Our Case Number: ACP-323851-25

Re: Proposed construction of the Celbridge Hazelhatch Mobility Corridor
Celbridge Town, County Kildare

Submission Regarding the Celbridge Hazelhatch Mobility Corridor Section 177 AE Planning Application (An Coimisiún Pleanála Case Reference: JP09.323851)

Figure 1: Location of cycling infrastructure issues

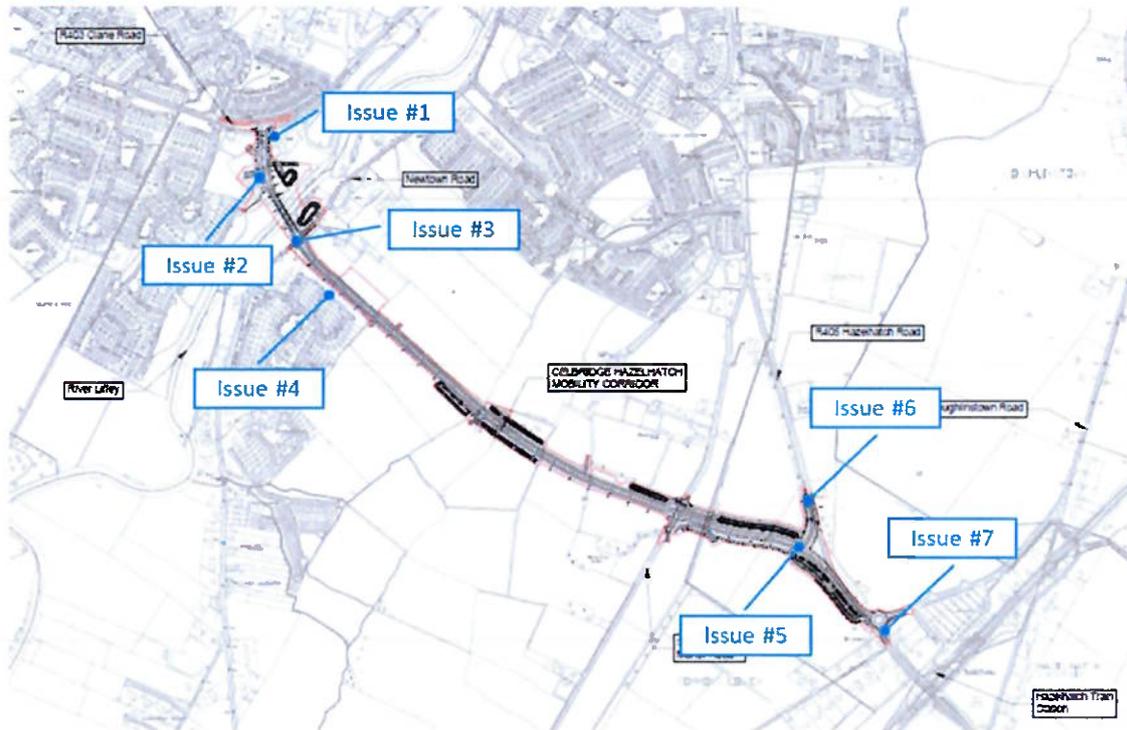
However, that provision could be further improved. The NTA's Cycle Design Manual¹ provides guidance as to the best practice for the design of new cycling infrastructure. However, many of the crossings and junctions in this project proposal fall short of that guidance and should be revised. See Figure 1 for the location of each of the issues discussed below.

- Given the number of deviations from the Cycle Design Manual, a full review of the cycling infrastructure should be undertaken prior to proceeding to the next stage of design.

Figure 5: Protected junction from the NTA's Cycle Design Manual, 2023.

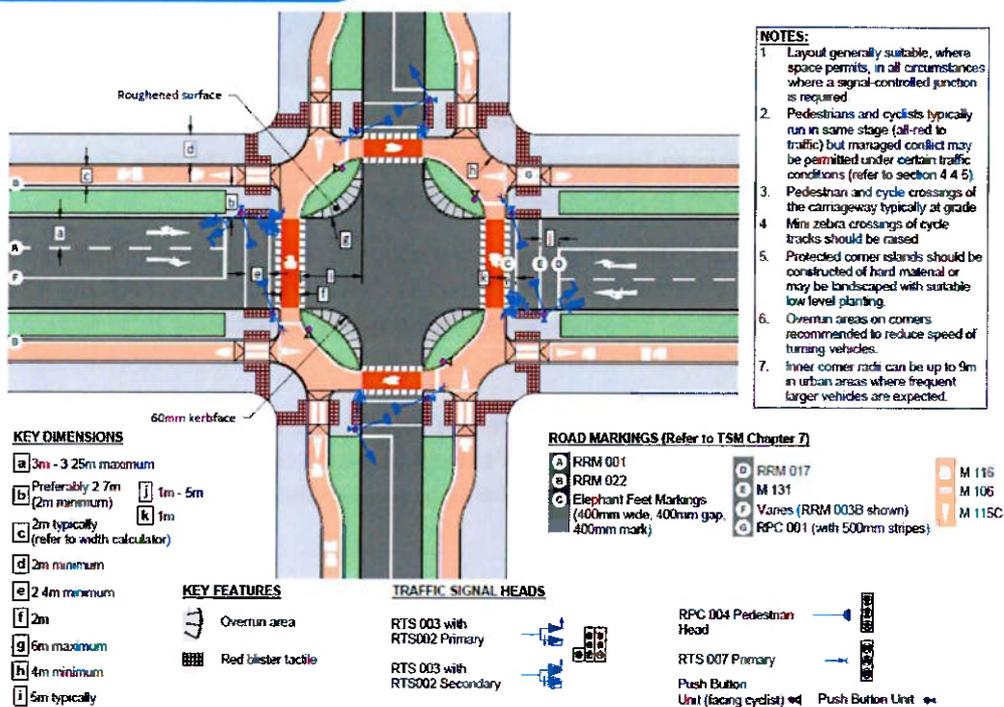
It is notable that priority is not given to the cycle track crossing this junction. This presumably is due to the level of traffic on the Newtown Road. However, if the traffic is at such a level, then the junction itself should not have a shared space between cyclists and pedestrians. Mode separation on the three crossings, such as that shown in “TL501 Protected Junction” from the Cycle Design Manual and in Figure 5, should be deployed.

- Separate pedestrian and cyclist spaces at the Newtown Road junction crossings, as per the Cycle Design Manual best practice.

Figure 6: Hazelhatch Road signalized junction with six cycle tracks and four pedestrian points converging on two shared spaces connected by a shared (circa) 4m-wide crossing.

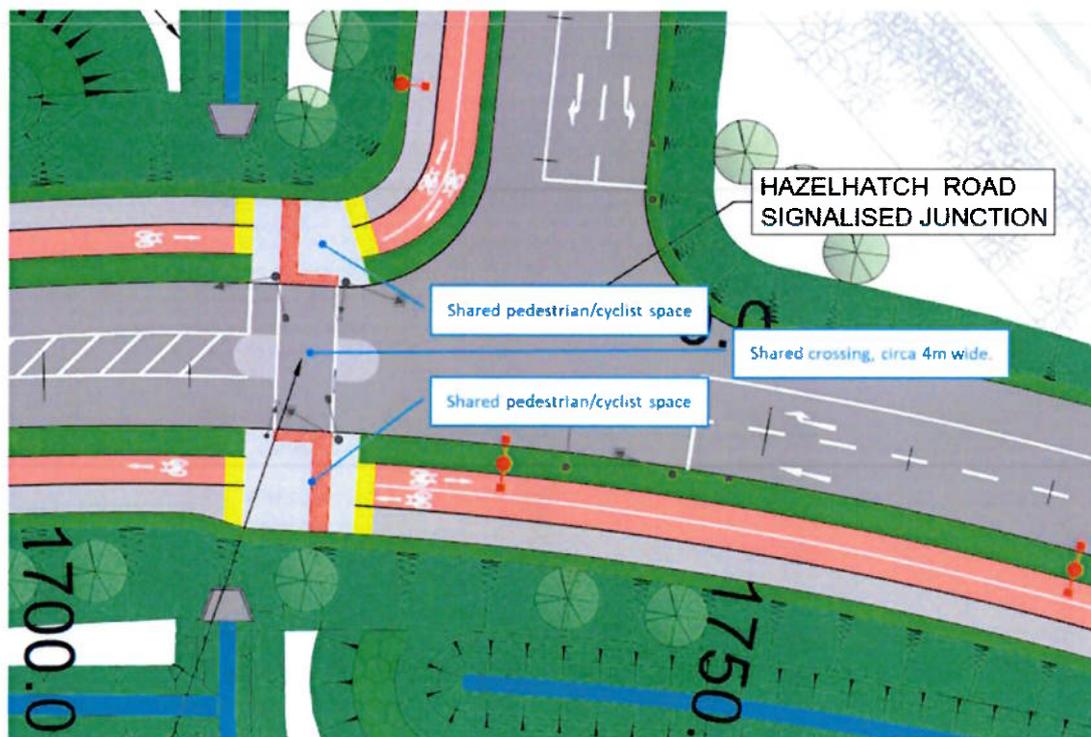
The issue here is similar to that at the Newtown Road junction, except now there are six cycle tracks and four pedestrian paths converging at two shared spaces. Mode separation, utilizing the principles given in Figure 5, is absolutely essential here. Furthermore, there is enough room for such a modification.

- Separate pedestrian and cyclist spaces at the Hazelhatch Road junction crossings, as per the Cycle Design Manual best practice.

Figure 7: Signalized cycle crossing to a two-way cycle track, as given in the NTA’s Cycle Design Manual, 2023.

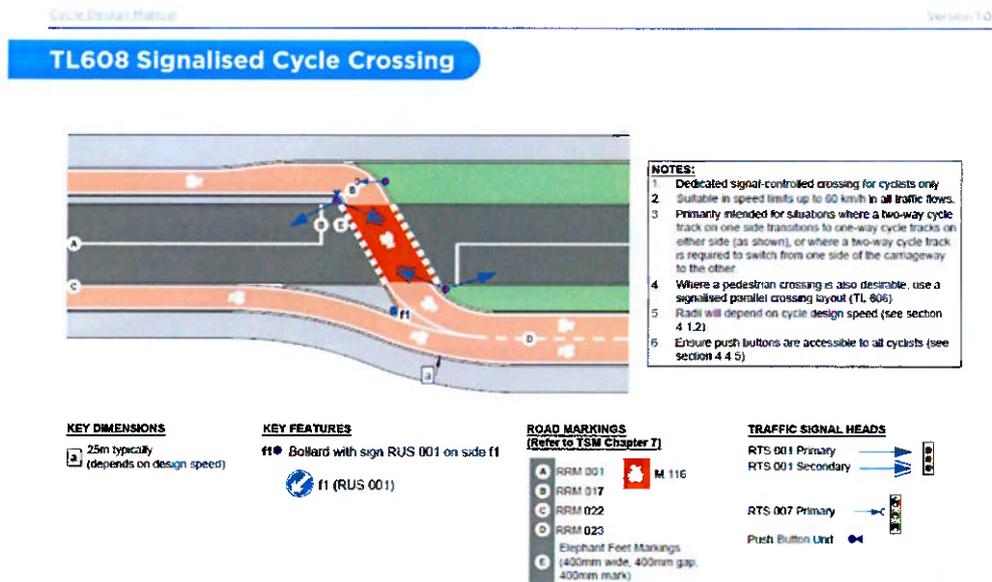
To enter the new two-way cycle track on the Hazelhatch Road, southbound cyclists are expected to take control of the southbound vehicular lane and wait for a safe gap in northbound traffic before entering the new two-way cycle track. This is a manoeuvre for a confident cyclist only. Crossing dismounted, on foot, is an alternative approach, but will be very challenging in peak hour traffic.

- A signalized crossing for southbound cyclists to join the two-way cycle track as per “TL608 Signalized Cycle Crossing” in the National Transport Agency’s Cycle Design Manual and shown in Figure 7.

Figure 8: Signalized parallel crossing as given in the NTA's Cycle Design Manual, 2023.

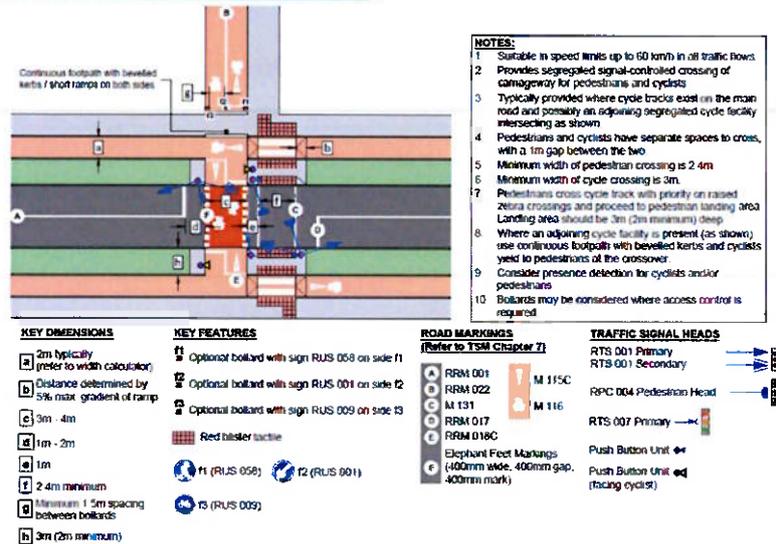
Here, there are four cycle tracks and four pedestrian paths converging at two shared spaces. Mode separation in the crossing, such as that shown in “TL606 Signalized Parallel Crossing” from the Cycle Design Manual and in Figure 8, is absolutely essential here. Furthermore, there is enough room for such a modification.

It is also worth noting that that this crossing is close to the Grand Canal Greenway. It will be less than 800m from the crossing (along the R504 running south from the roundabout) to the nearest access to the greenway.

- Separate pedestrian and cyclist spaces at the Hazelhatch Road junction crossings, as per the Cycle Design Manual best practice.
- Provide appropriate tie-ins at the crossing for cyclists on the R504 south towards the Grand Canal Greenway.

Figure 9: Proposed location for new bus stops, close to the Newtown Road junction.

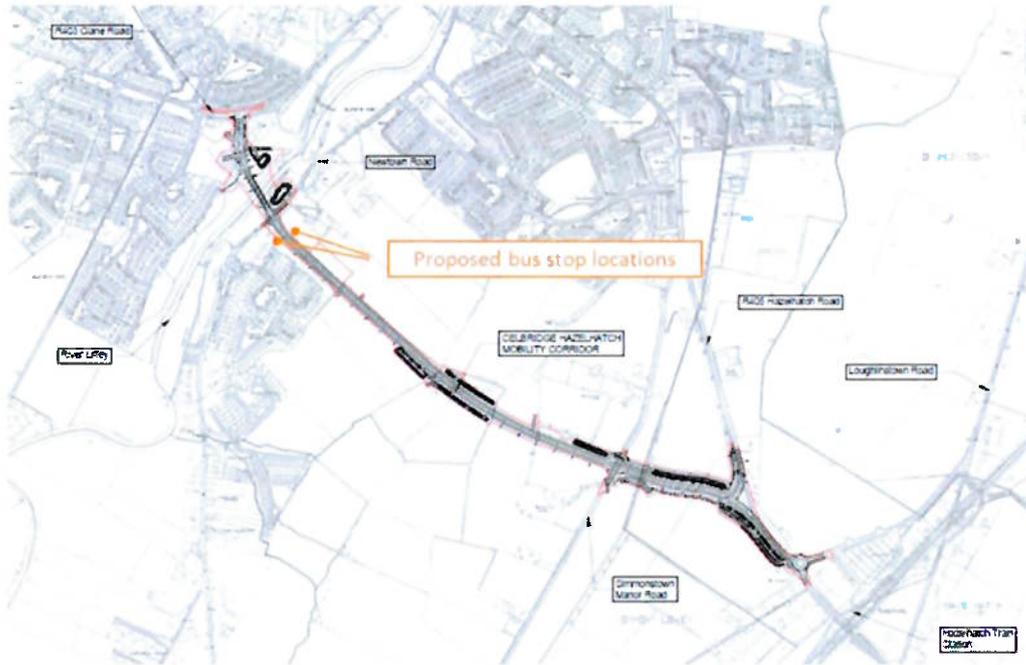
No bus network infrastructure is included in the plans.

With no plans available for the Simmonstown KDA (Key Development Area, as outlined in KCC's *Celbridge Local Area Plan 2017-2023*) to the north of the mobility corridor, it is understandable that bus stops are difficult to plan in, along that road. However, with no permeability planned from the Temple Manor residential estate, there is a clear value proposition for inbound and outbound bus stops on the mobility corridor link road, close to the Newtown Road junction. These bus stops would service the existing

- Add two new bus stops, one on either side of the new mobility corridor link road, roughly in the positions as shown in Figure 9.

Figure 10: Zoning map for the lands around the proposed new bridge. Source: KCC's Celbridge Local Area Plan 2017-2023.

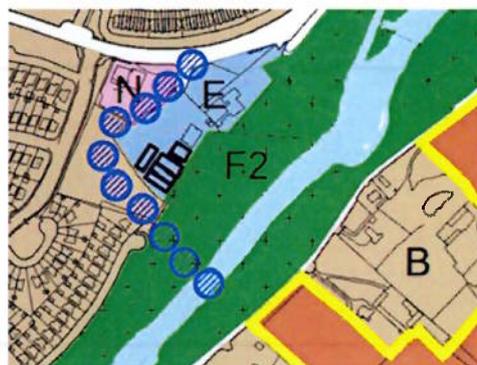
The **Kildare County Development Plan 2023–2029** classifies the River Liffey corridor as a “**Class 4 (Special)**” landscape, where development can have significant adverse effects on landscape character.

The **Celbridge Local Area Plan 2017–2023** zones these riverside lands as ‘**F2: Strategic Open Space**’ and overlays them with a **Historic Landscape Area (HLA)** specific zoning objective, reinforcing the need for careful stewardship. The objectives of the F2 zoning are “*To preserve, provide for and improve recreational amenity, open space and green infrastructure networks*”. Objective **HLA01.1** is “*To protect the special landscape character of historic landscape areas and ensure that new development enhances the special character and visual setting of the historic landscapes outlined on **Map 13.1** and to prevent development that would have a negative impact on the character of the lands within the Historic Landscape Areas.*”.

Figure 12: The purple arrow overlays future movements of people onto Figure 5 from the Celbridge LAP.

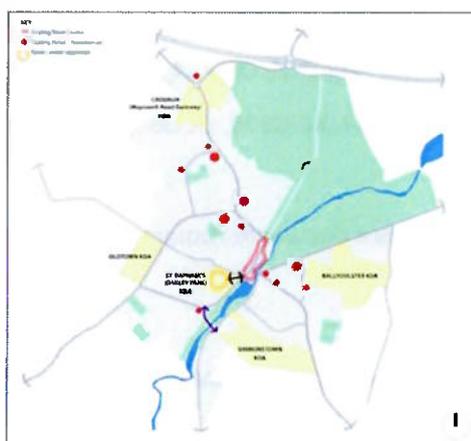
2. The prime location of the site for the proposed bridge close to the ***future town centre expansion*** (KDA1: Oakley Park), the ***existing neighbourhood centre*** on the Clane Road, and the future Simmonstown KDA, means that it will evolve as a hub for movement of people between residential areas and new retail / services.
